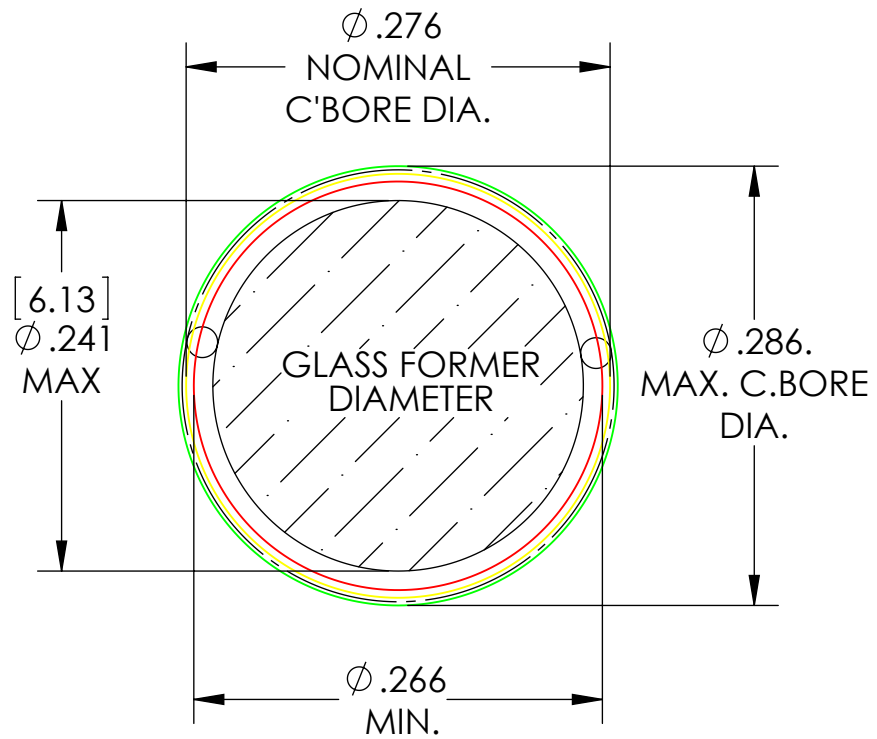
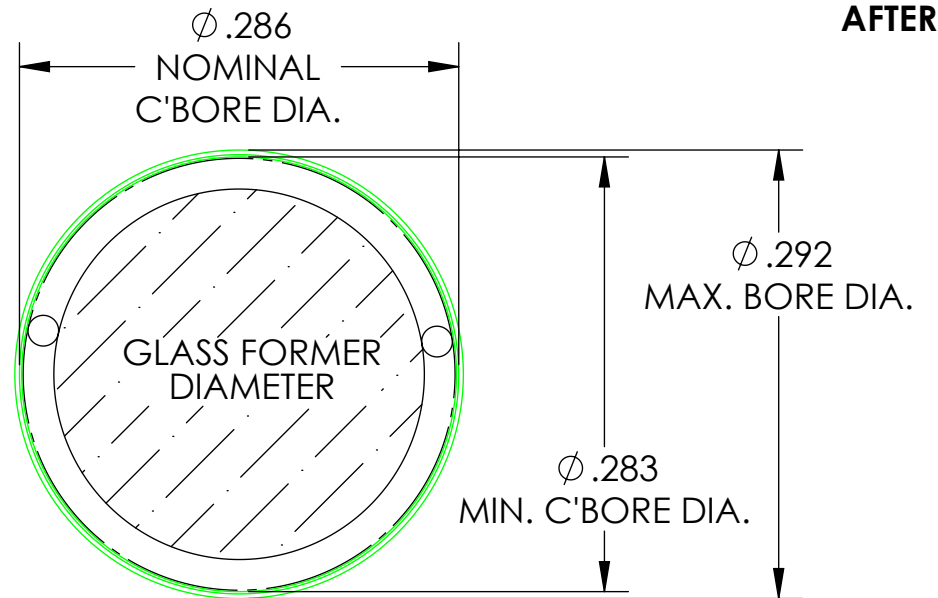
NOTE: GLASS FORMER DIA. 6mm +/- .005
PER TITLE BLOCK TOLERANCES
